Wucho Fashion Ltd.

AFSAR UDDIN SHEIKH COMPLEX, HAZI LIAKAT, JAMGARA

3rd May 2018

Typical floor layout plan

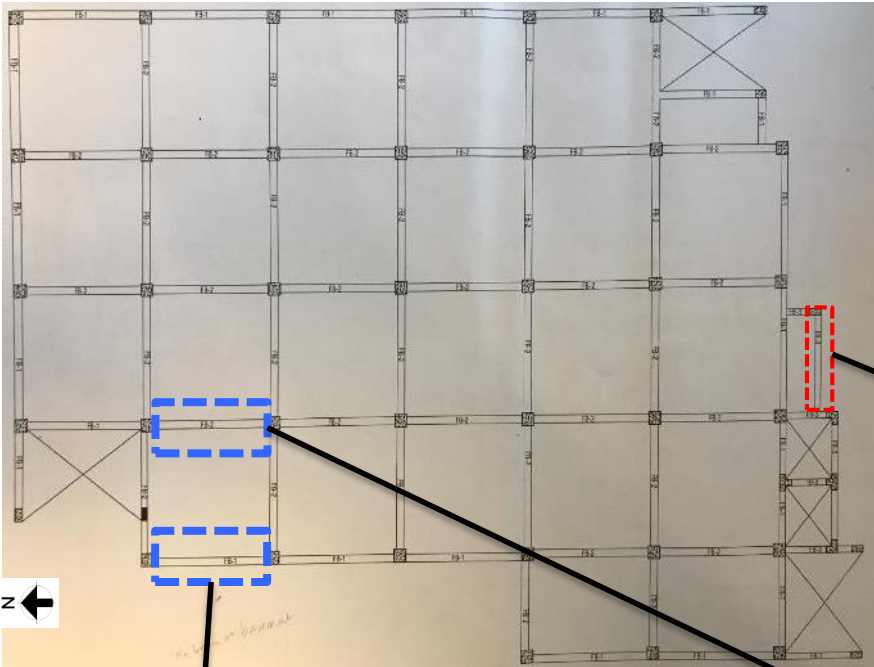
**Column stresses marginally exceeds the
normal design limit**

Cursory calculation indicates that columns appear to be stressed marginally above normal design limits considering floor built up loads and 3kPa live loads on typical floor.

Building engineer is required to review the column stresses and prepare allowable floor load plan.

120~380 mm build up area in toilet zone.

Uncontrolled loading exceeds 3 kPa

Beam-column layout in provided drawing

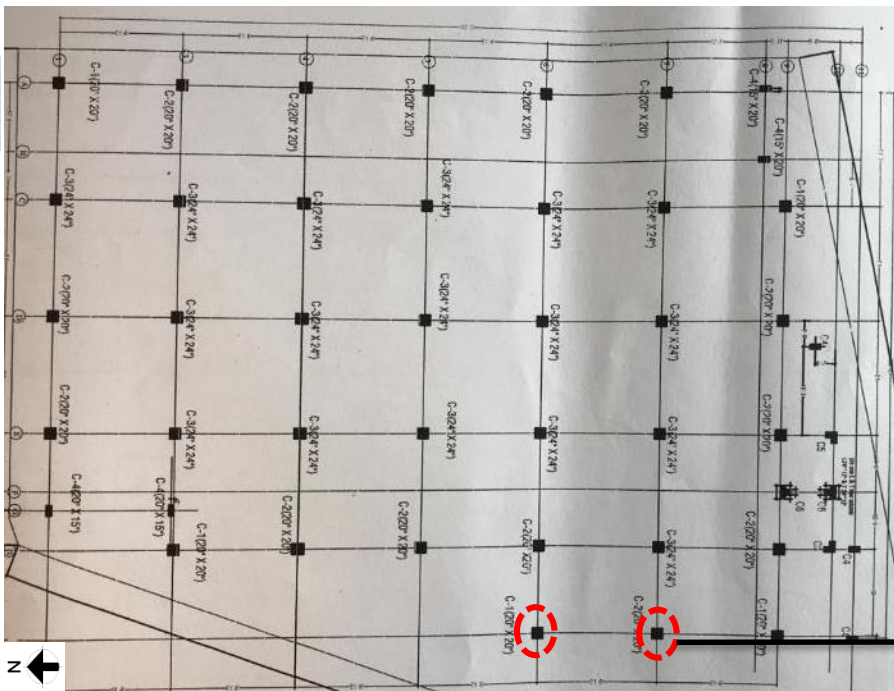
The marked beam was absent on 1st floor under south side toilet zone but the beam was shown in beam layout.

The marked beams were absent in basement floor on ramp area but the beam was shown in drawing.

Column layout in provided drawing.

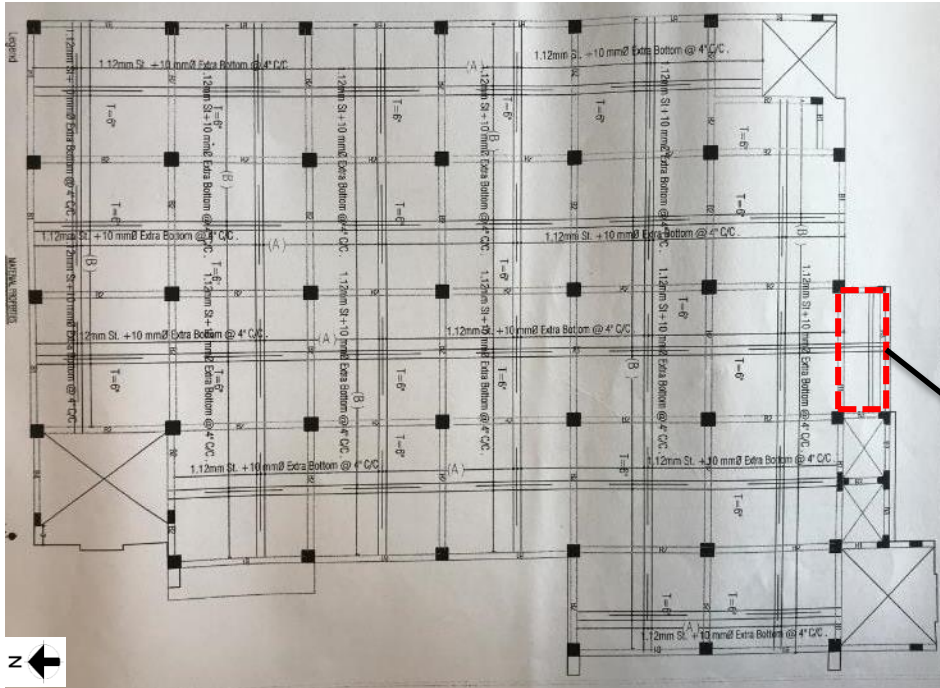
Circular columns were observed in marked position which continued up to 1st floor. But in column layout, C-1 and C-2 type rectangular columns were shown at the circular column's position. In addition, no detail of circular column was found in the column schedule.

Slab layout in provided drawing.

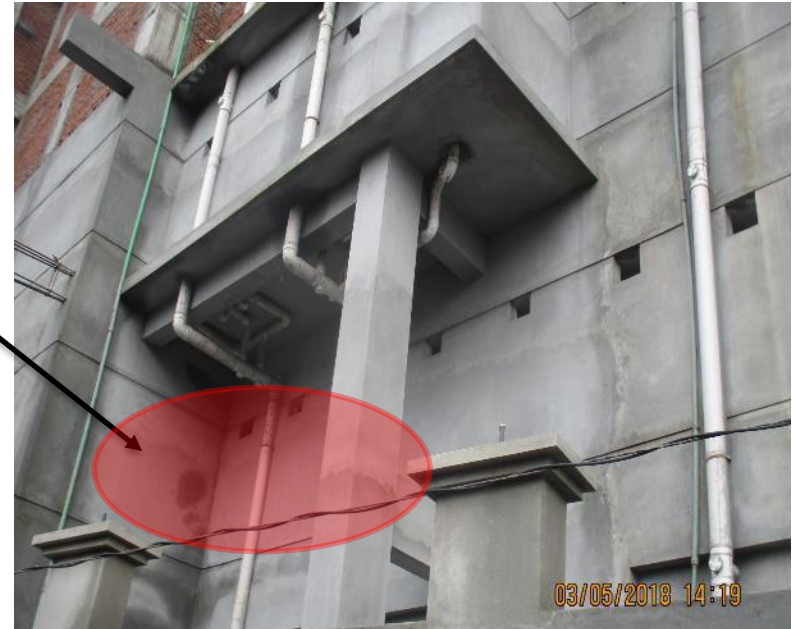
No slab was found under the toilet zone on 1st floor. Whereas, the slab was shown in slab detail drawing
